DESIGN COMMENT AND RESPONSE (DCR) D2G-MP13-F-4033

Ipswich Motorway Upgrade

Dinmore to Goodna

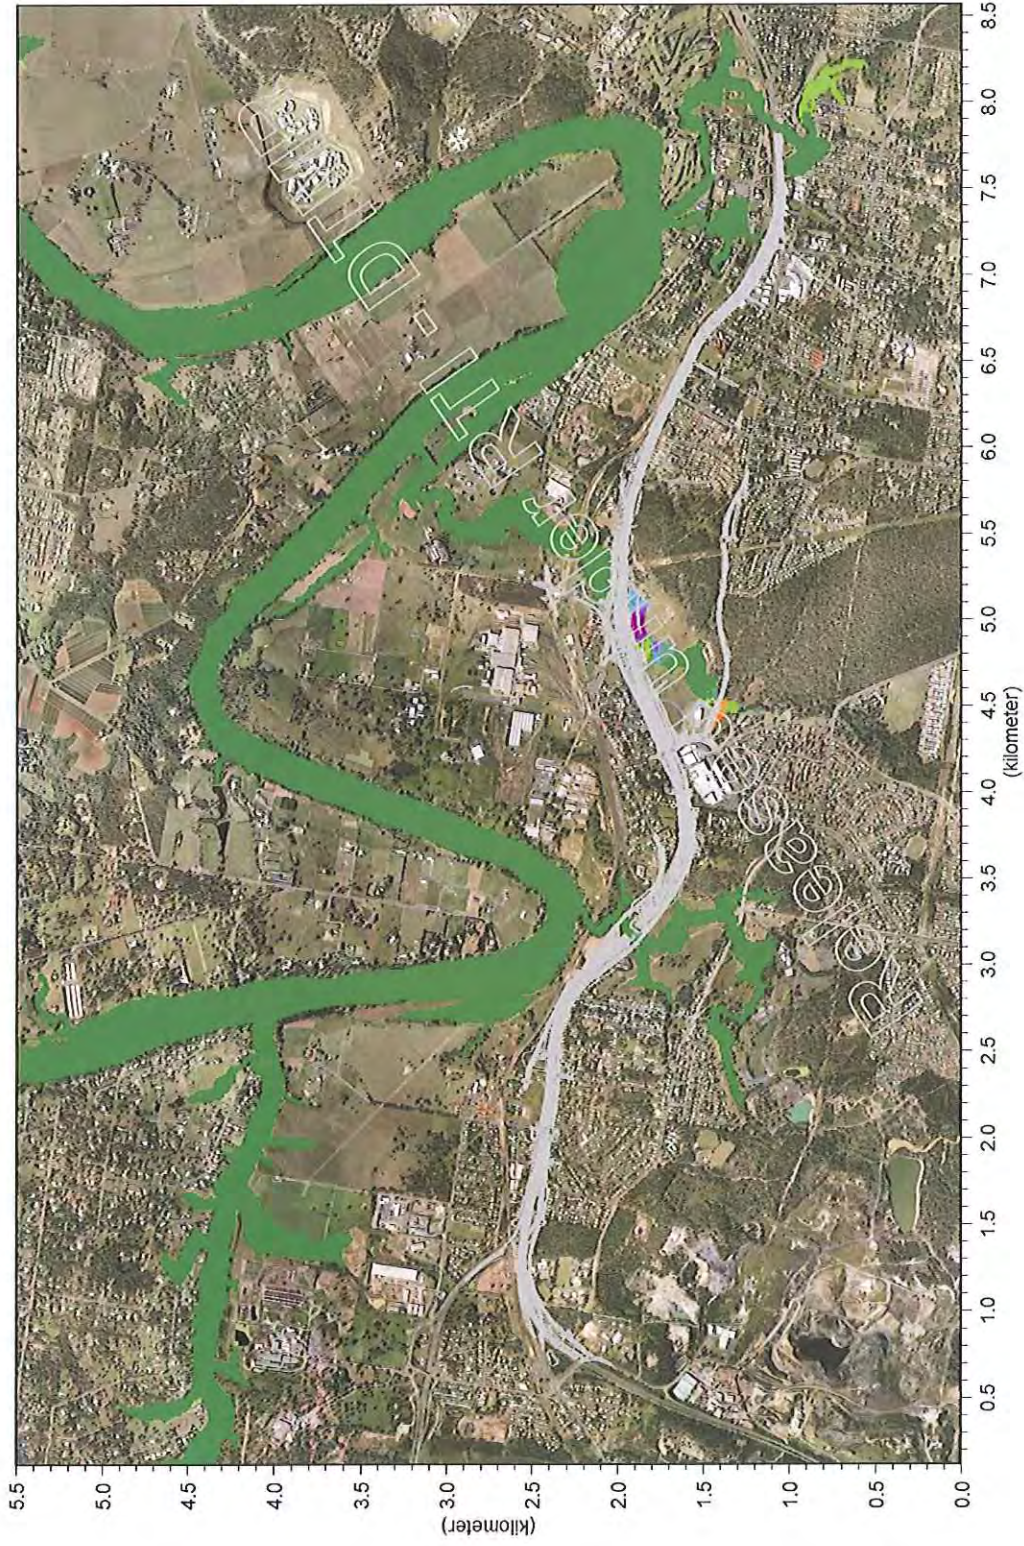
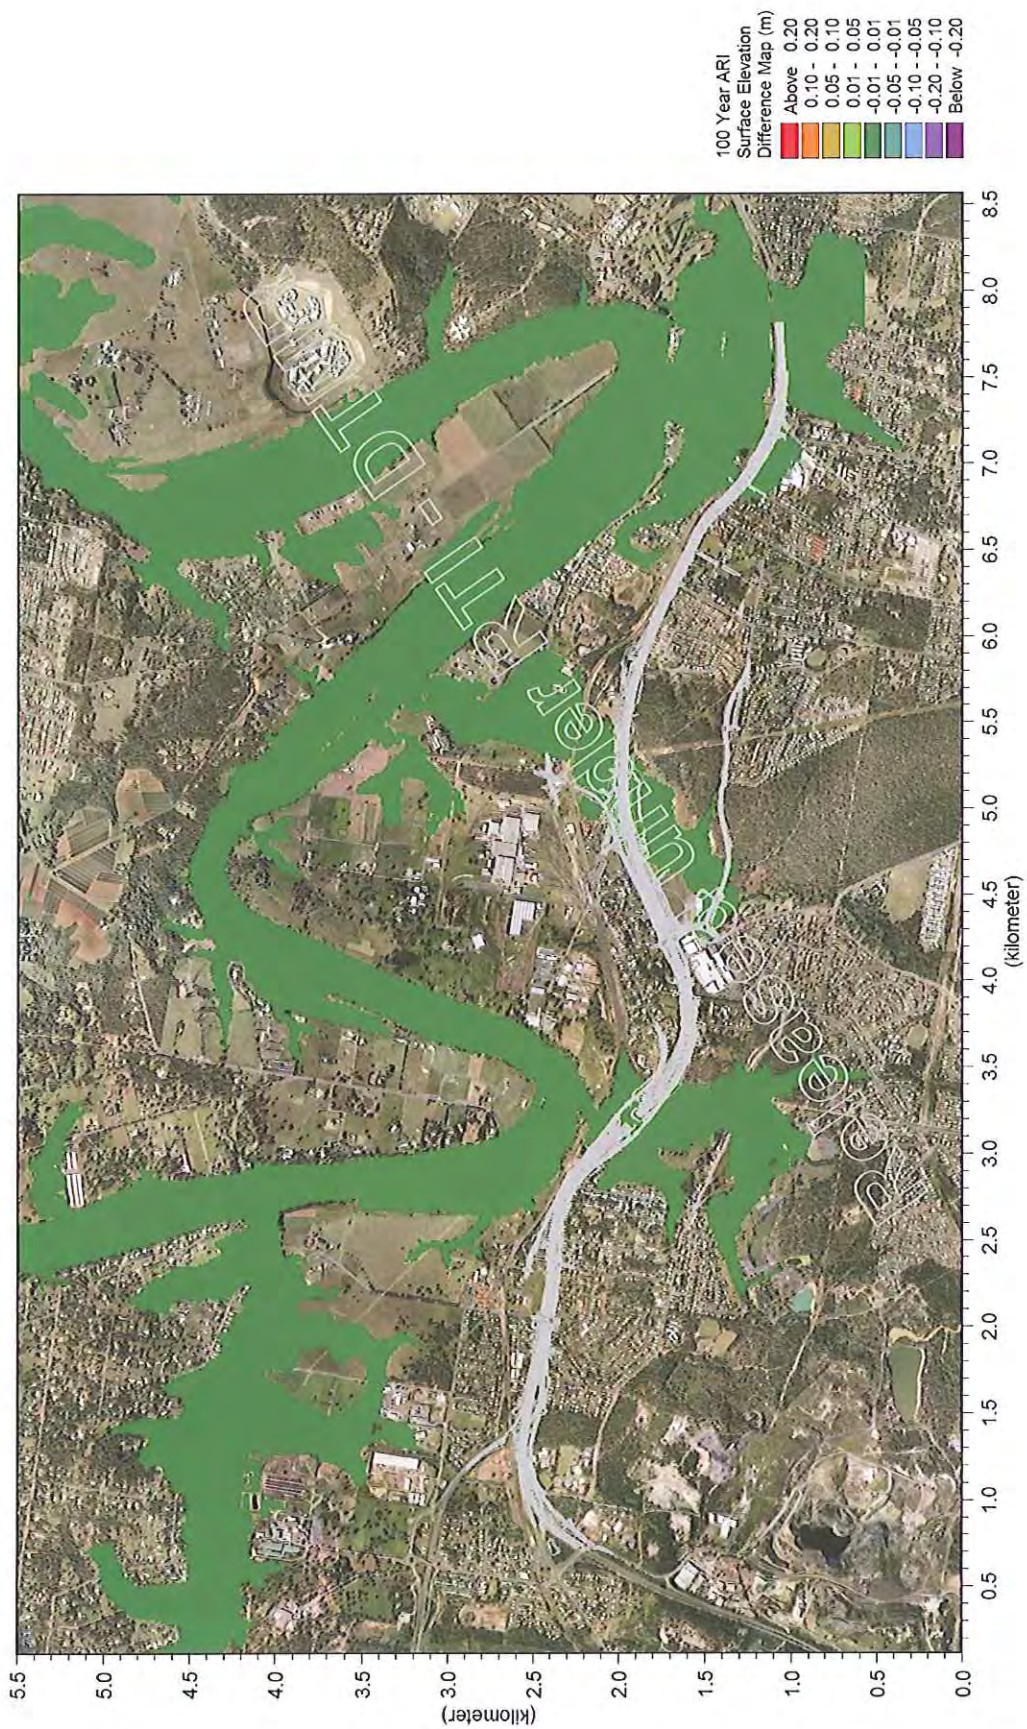
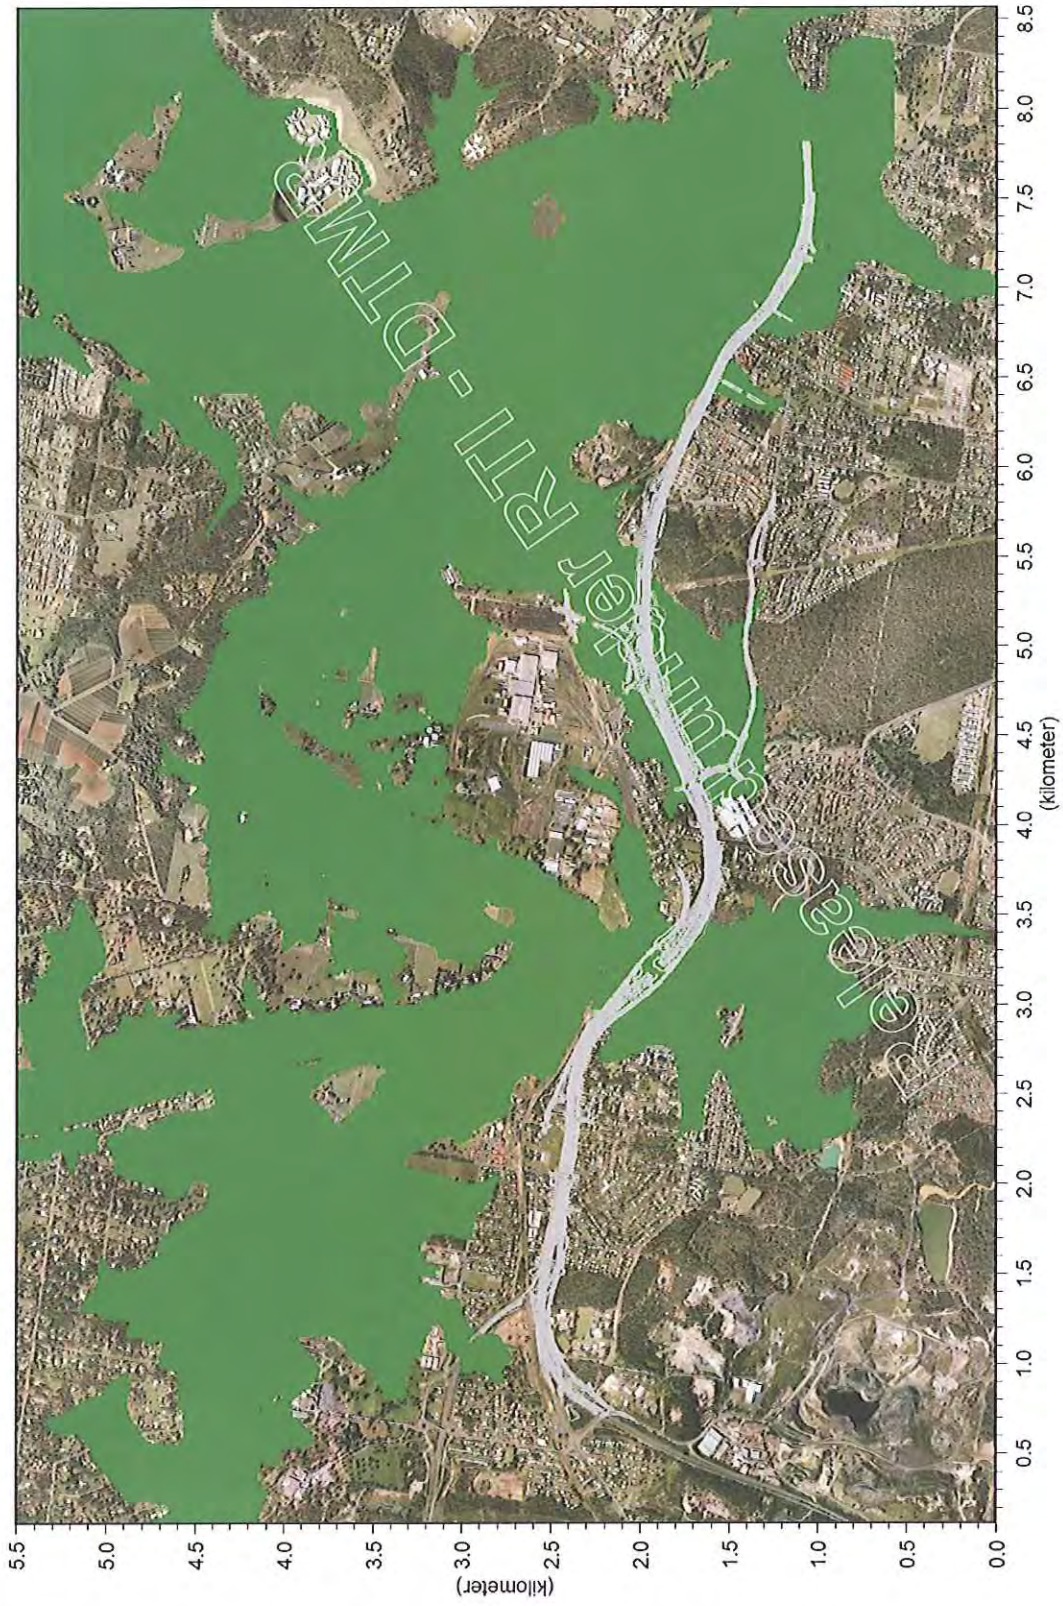
| Ref No | Reviewer | Reference | Reviewer Comment | Designer Comment | Status - Originator Comments Internal Use Only |
|--------|--------------------|---------------------|---|---|--|
| 19 | Hyder AV | General (from 15%) | Please supply a figure for the 1:100 ARI event indicating water levels obtained from the different models in the report. Specifically indicating the head loss from the different structures along the model. The graphs should also indicate the position of tributaries, trunk drains and other infrastructure. | There is only one model in this report and this model was undertaken for three ARI design events (20, 100 and 2000). The resultant water surface levels are presented in separate figures for each event. Table 4-3 presents the before and after scenarios. In conjunction with Figure 4-34, and headloss can be derived from the data in this table | Closed 11/2/10 |

Figure 4-35: 2000 year ARI afflux map

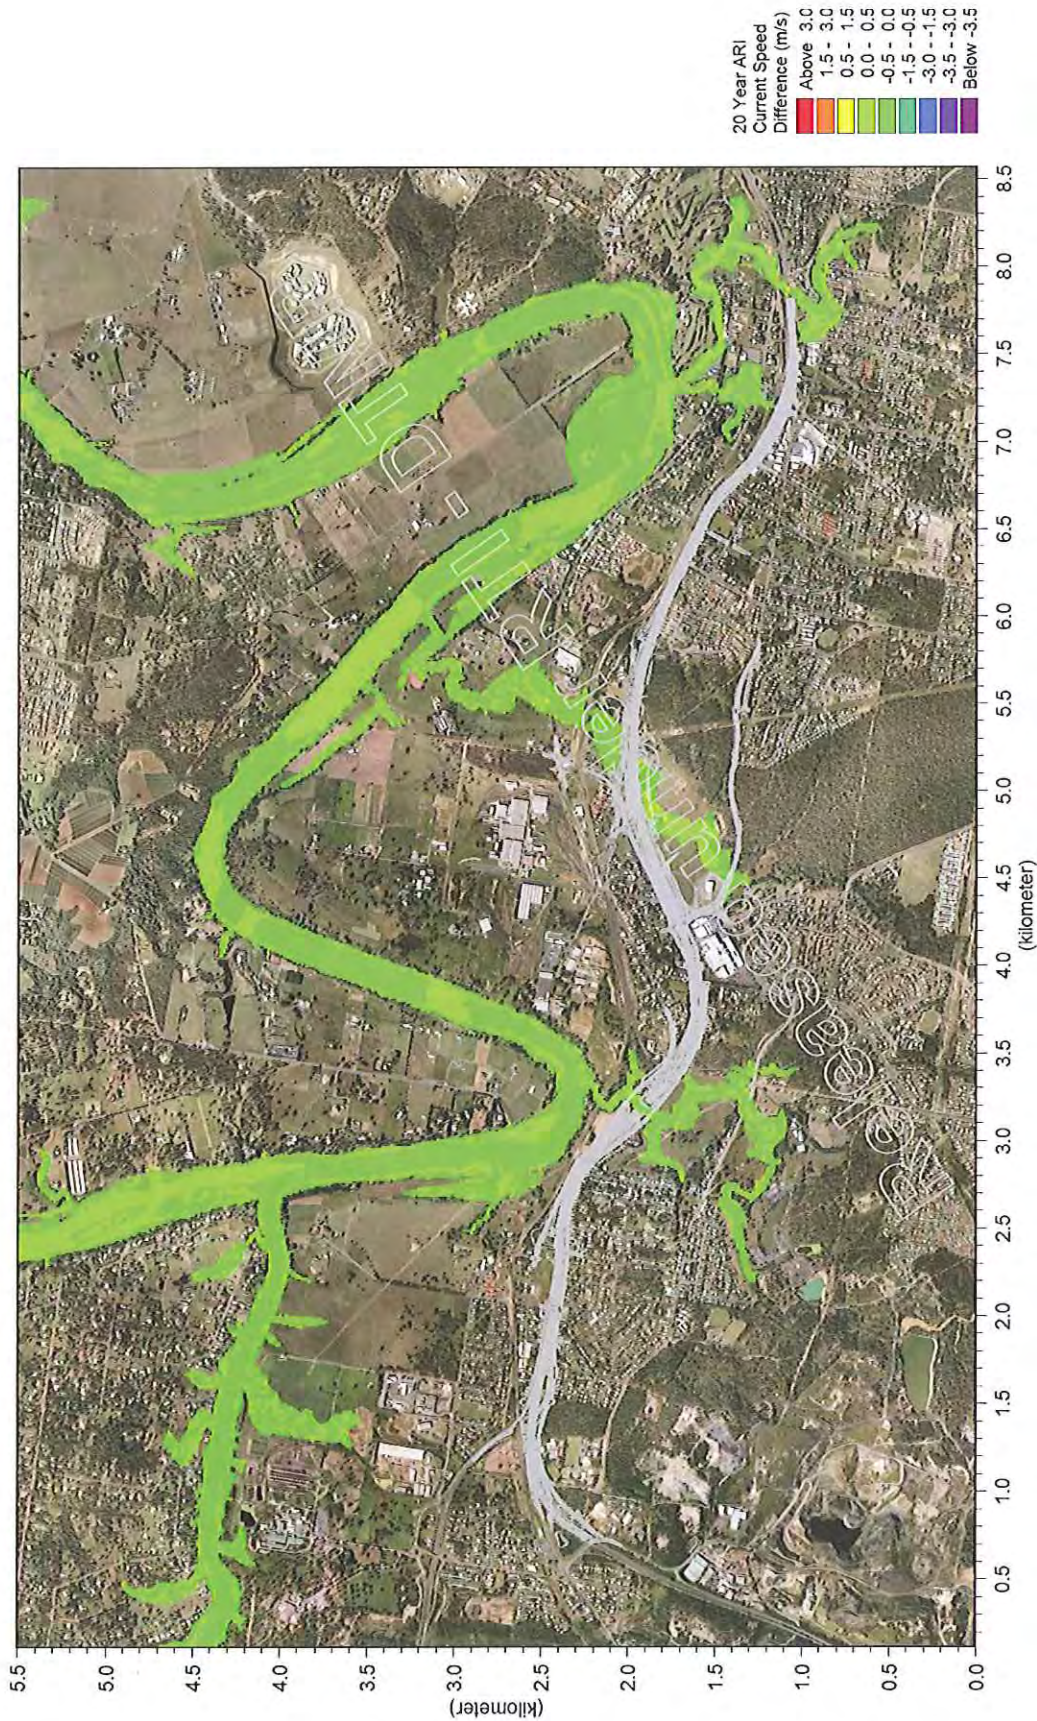
| Ref No | Reviewer | Reference | Reviewer Comment | Category (Minor / Moderate / Major) | Designer Comment | Status - Originator Comments Internal Use Only |
|--------|----------|------------------------|---|-------------------------------------|---|--|
| 36 | Hyder AV | Cl. 4.2.6 | Please provide in the plan the locations of bridges, L1, L2 etc for better understanding of the flood report | Moderate | Locations have been detailed on Figure 4-35 in the report. | Closed 11/2/10 |
